HL440

Material change of the Recessed washing device trap DN40/50

HL440 Concealed washing device trap with mechanical

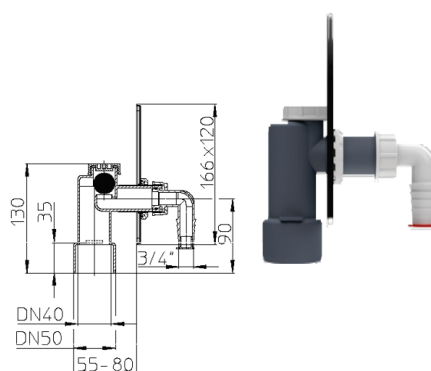
From now on, the drain body of the HL440 washing machine trap will be manufactured from polypropylene (PP) instead of the previously used polyethylene (PE).

Due to this change, the connection of the washing machine trap to the waste pipe is now only possible using a push-fit connection. A welded connection with PE pipes is no longer possible.
